Staff Report

To: Salt Lake City Planning Commission
From: John Anderson, 801-535-7214, john.anderson@slcgov.com
Date: October 12, 2016
Re: PLNPCM2016-00585 Dixon Medical Office Building Conditional Building and Site Design Review

Conditional Building and Site Design Review

ATTACHMENT C: BUILDING ELEVATIONS &
RENDERINGS

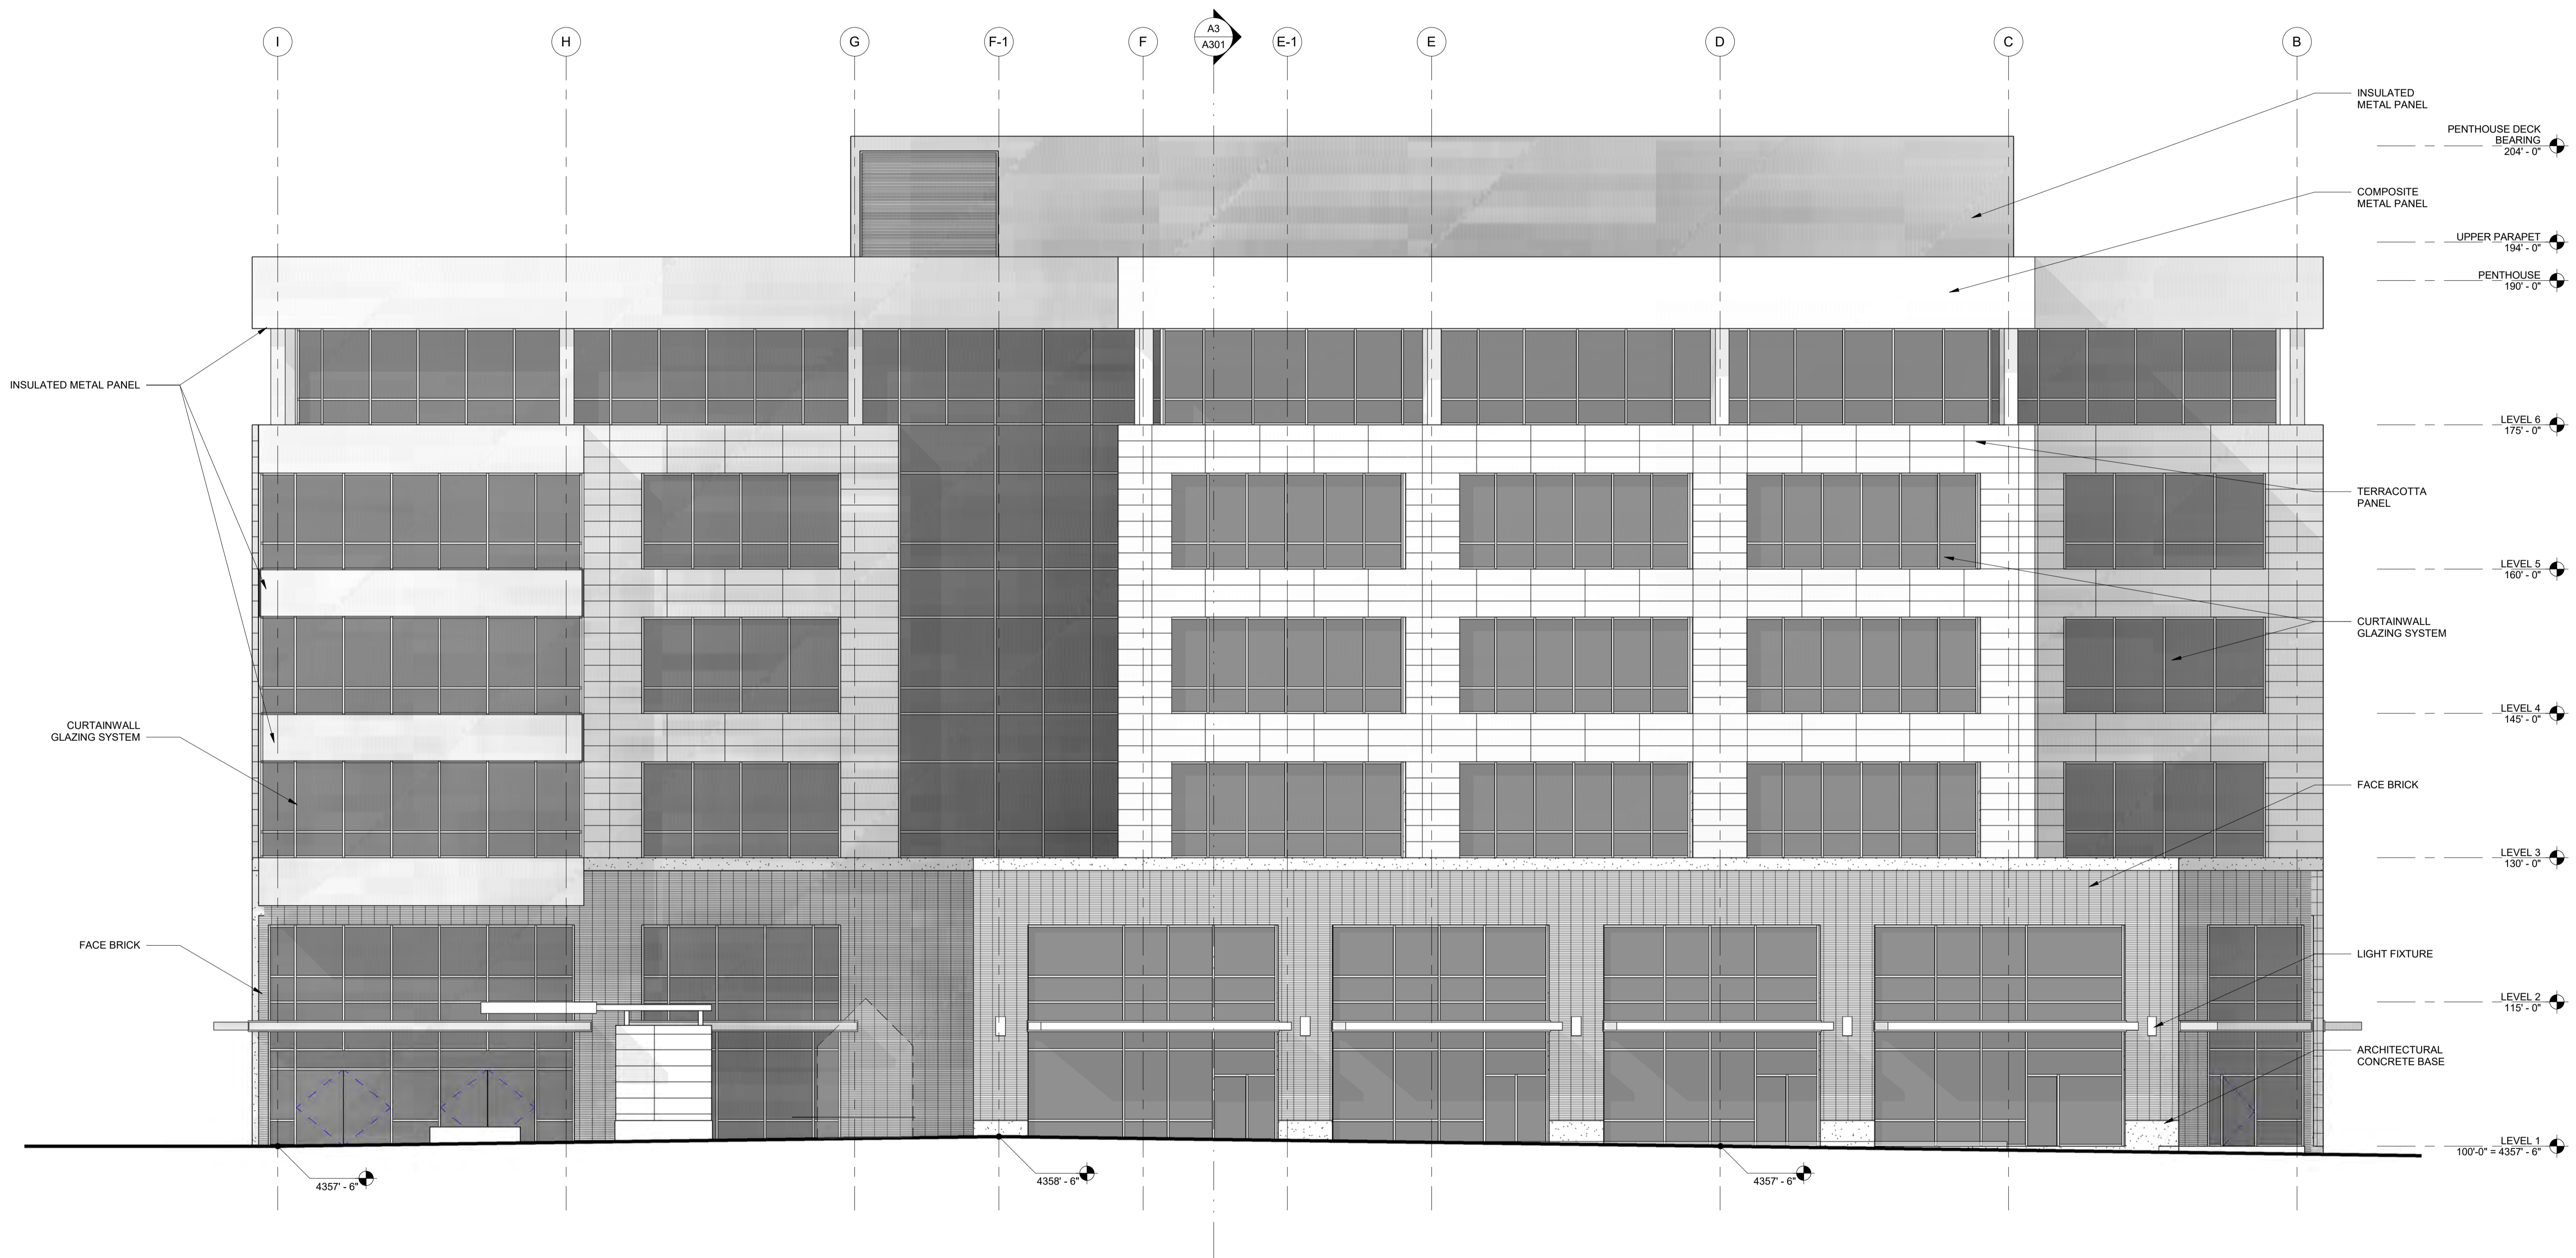
Planning Division Comment: Please provide more information regarding the circulation on the site. It is not clear that pedestrians will be able to safely cross the proposed private street especially those that utilize mass transit to access the site. Also Boulder Ventures has provided a more detailed plan for the development of the walkway located on the west side of this property. Please verify whether or not this walkway will be developed in a manner that has been presented to staff. Moving pedestrians safely through the Granite Block has been a critical issue raised by the community.

Planning Division Comment: It appears that the loading docks will be located in the rear of the structure. Will these loading docks be screened as well?

Planning Division Comment: Staff cannot verify that this standard has been met. Please provide a more detailed landscaping plan.

Planning Division Comment: Staff cannot verify that this standard has been met. Please provide a more detailed landscaping plan and the amount of the property that will be landscaped.

FFKR Response: Please see the attached updated AS101 Site Plan: note that the proposed design includes crosswalks across the private drive that are raised to adjacent sidewalk levels in an effort to slow vehicular traffic and provide safe passage for pedestrians utilizing mass transit to access or move through the Granite Block. Also note that the walkway along the south and west sides of the drive have been developed in collaboration with Boulder Ventures, including the incorporation of paving patterns, planters, bollards, and seating elements to connect the three adjacent properties (Sugarmon, Dixon, and The Vue) and encourage safe and stimulating pedestrian passage.

FFKR Response: Please see attached, updated AS101. The proposed building will screen the loading dock on the south side, and site walls will screen the dock from the pedestrian plaza to the north and west. The actual loading dock will be located in a recessed section of level 1. The truck entrance to the dock area will be the only area open to view.

FFKR Response: Please see attached updated AS101

FFKR Response: 180,000 GSF total building area x10% = 18,000 sf public spaces required. 35,525 sf of landscape, plaza and public space provided. Please see attached site plan with those plaza and landscaped areas shaded. The plazas shall incorporate the following elements: sitting spaces that comply with K.a.ii.1, K.a.ii.2, K.a.ii.3.
